**29 CFR Part 1910**

**Walking-Working Surfaces, Personal Protective Equipment (Fall Protection Systems), and Special Industries (Electric Power Generation, Transmission, and Distribution); Corrections**

**ACTION:** Final rule; corrections to standards.

Figure D-8 – Dimensions of Standard Stairs

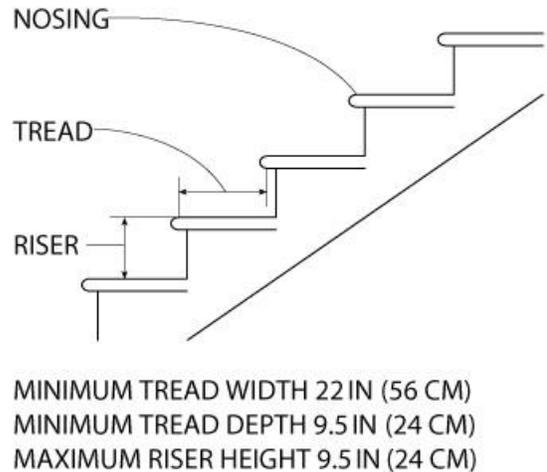
The figure at 29 CFR 1910.25(c) immediately after Table D-1 does not have a title even though it is referred to as Figure D-8 in § 1910.25(c)(4). The title of the figure

was included in the proposed rule (75 FR at 29137) but mistakenly left out of the final rule (81 FR at 82989). This document adds the missing title to the figure: “Figure D-8 – Dimensions of Standard Stairs”.

3. Amend § 1910.25 by revising paragraph (a) and the figure following Table D-1 in paragraph (c)(5) to read as follows:

Figure D-11 Guardrail Systems

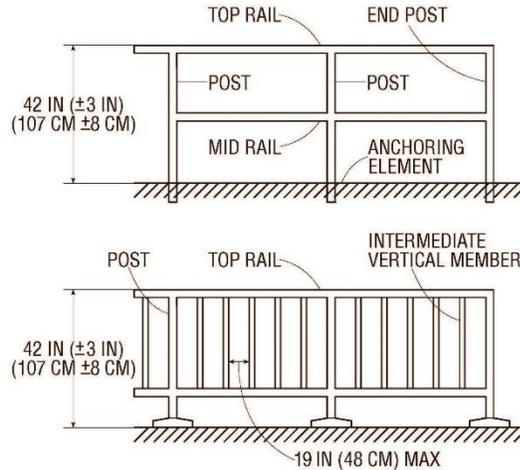
OSHA is correcting Figure D-11 to include labels identifying the top rail and end post in the top diagram of the figure. The words “top rail” and “end post” were mistakenly omitted when the final rule was published in the *Federal Register* (81 FR at 82995).

5. Amend § 1910.29 by revising paragraph (b)(1) and Figure D-11 to read as follows:

(1) The top edge height of top rails, or equivalent guardrail system members, are 42 inches (107 cm), plus or minus 3 inches (8 cm), above the walking-working surface. The top edge height may exceed 45 inches (114 cm), provided the guardrail system meets all other criteria of paragraph (b) of this section (see Figure D-11 of this section).
